Harvesting equipment — Blades for agricultural rotary mowers — Requirements

AMENDMENT 1

Reference number ISO 5718:2013/Amd.1:2019(E)

Figure 4

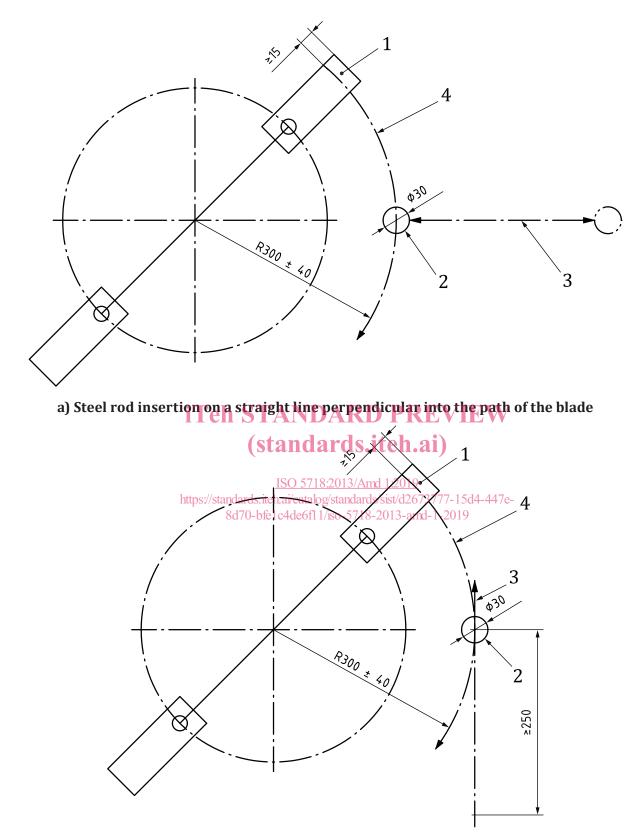
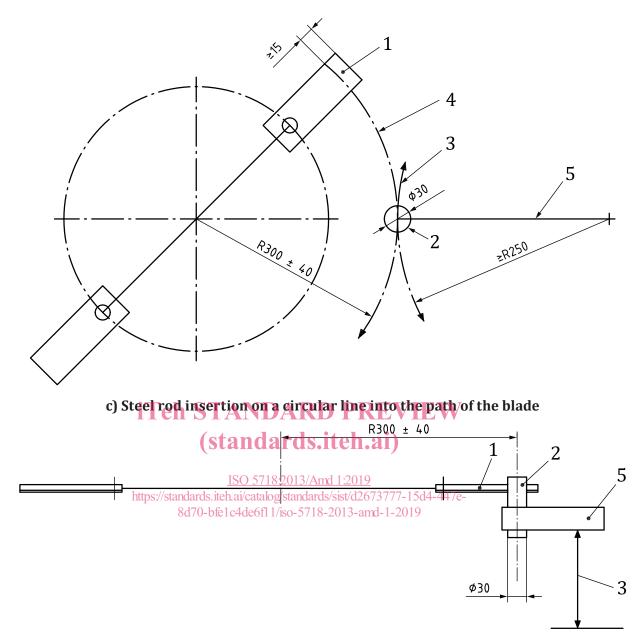
Replace Figures 4 a), b), c) and d) by the following:

b) Steel rod insertion on a straight line tangential into the path of the blade

d) Steel rod insertion on a straight line from below into the path of the blade

All blades selected for impact testing shall be tested on a test fixture as shown in Figure 4.
